A096474

09th December 2020

Response to comments received from Regulatory Officer, Environmental Health (Mr Mark Moss) at Havant Borough Council (HBC) received on 23rd September 2020 regarding the submitted Noise Assessment by WYG (ref A096474 dated 20th May 2020) for planning application reference APP/20/00441.

Figure 1 – ProPG Risk Assessment Stage; Existing Daytime $L_{Aeq16hour}$ Noise Levels

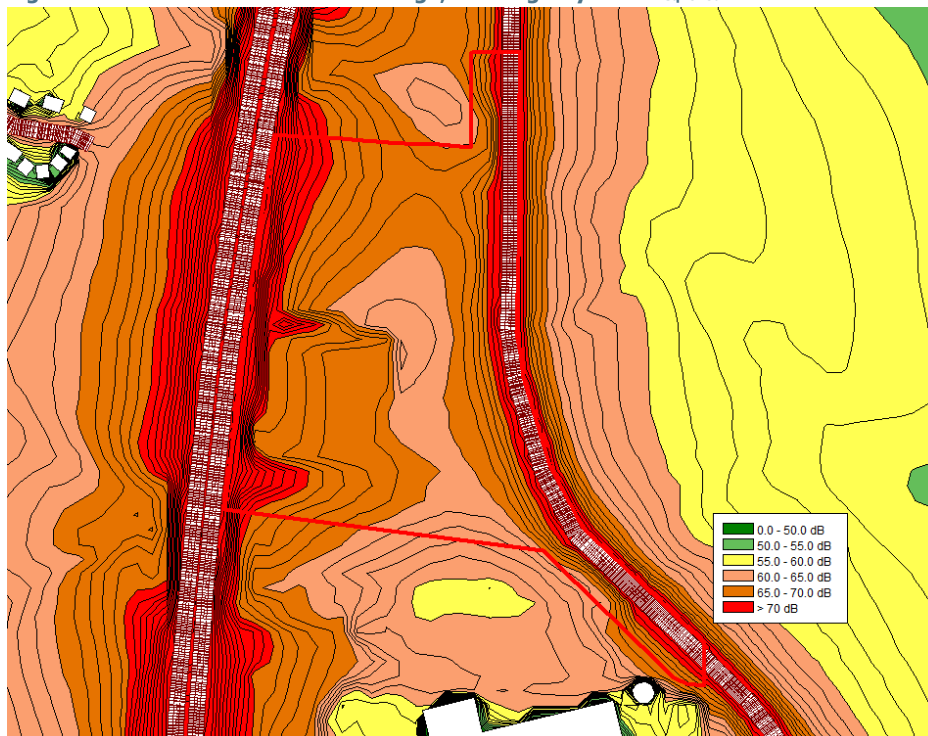
- a. It would be appreciated if figures depicting the suggested levels within the key on both SK03 & SK04 be provided as is done for SK05 to SK07.

- b. to assist with understanding the noise contour plotting in SK03 & SK04, can it be clarified as to why the daytime noise levels appear to be medium to high, whereas the night time levels are depicted as mainly high; this also being corroborated in Table 5.1.

The noise levels within the key on both SK03 & SK04 can be referred to in Figure 2.1 of the noise assessment and cross-referenced with the ProPG noise risk categories (Professional Practice Guidance on Planning & Noise). However, for clarity we have included both figures (Figure 1 and Figure 2) below with a key depicting the specified levels.

Referring back to Figure 2.1 of the original noise assessment. Noise levels considered to be 'high-risk' when assessed in accordance with ProPG are 70 dB and above during the day and 60dB and above at night. The colours shown in the two noise contour plots above (Figures 1 & 2) represent different noise levels depending on whether it is daytime or night-time, as shown in the two keys for respective plots.

Figure 3 – Location of Extended Bund / Barrier

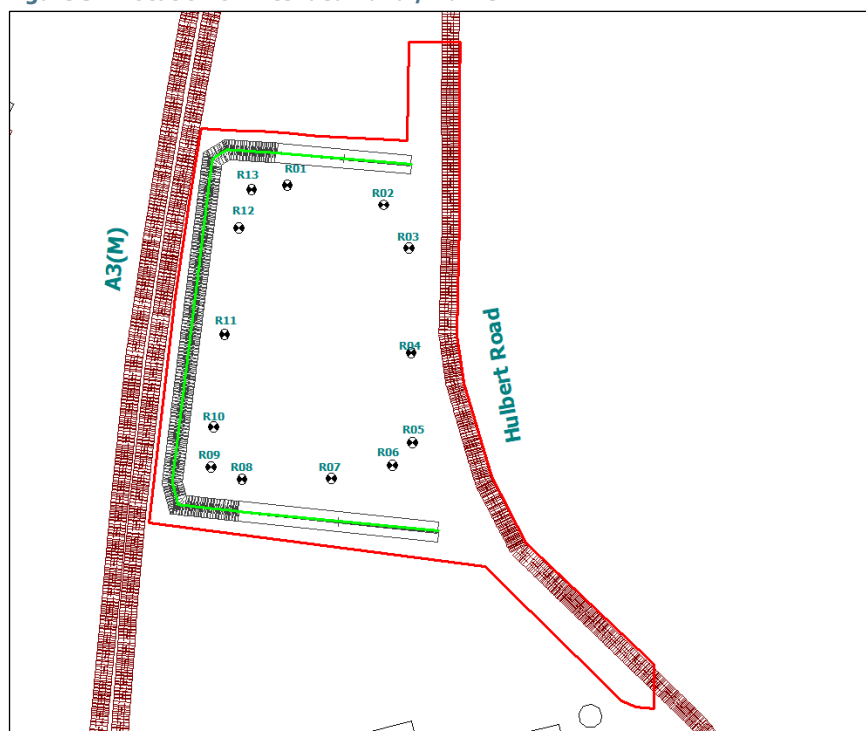
- c. with SK05 to SK07, if the return legs of the bund wall / acoustic fencing were to be extended further along both the north & south boundaries, what impact might that have in reducing noise levels further within the residential portion of the site.

If the bund and acoustic barrier were to be extended as shown indicatively in Figure 3 below, there would be marginal additional noise reduction of up to 2.2 dB at R01 during the day and 1.4 dB at night, as shown in Tables 1 and 2 below, when compared to the proposed barrier alignment. An extension to the proposed barrier alignment is therefore not considered necessary.

Figure 4 – Daytime L_{Aeq} Plot at 8m

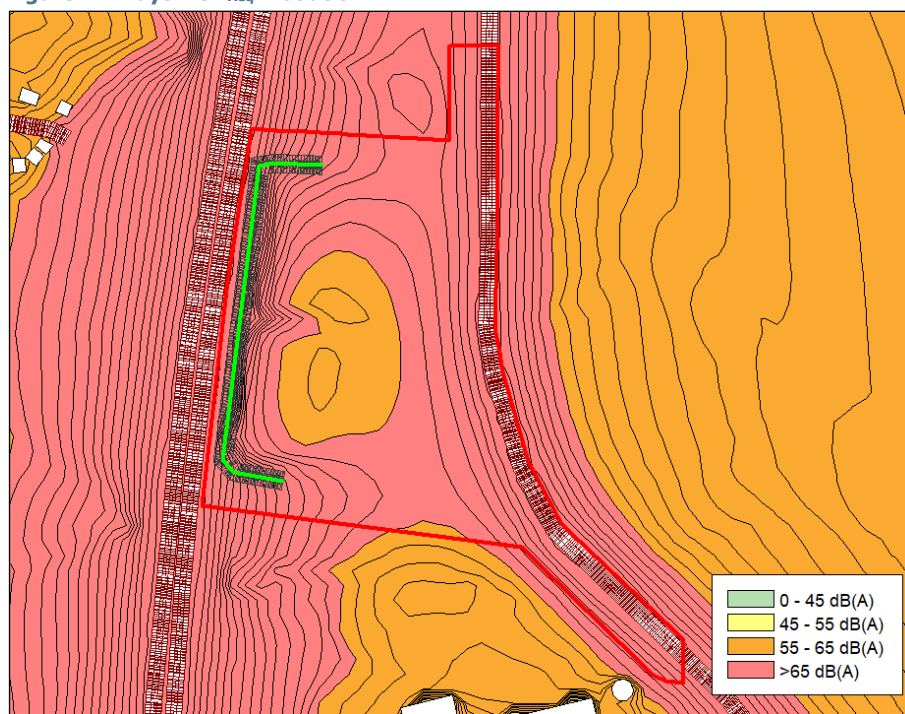
- d. the heights of 1.5m & 4m have been used for modelling and plotting purposes for the site. Are noise plotting predictions available for potential noise levels at 8m & 12m?

Figures 4 – 7 below show daytime and night-time noise contour plots at receiver heights of 8m and 12m as requested.
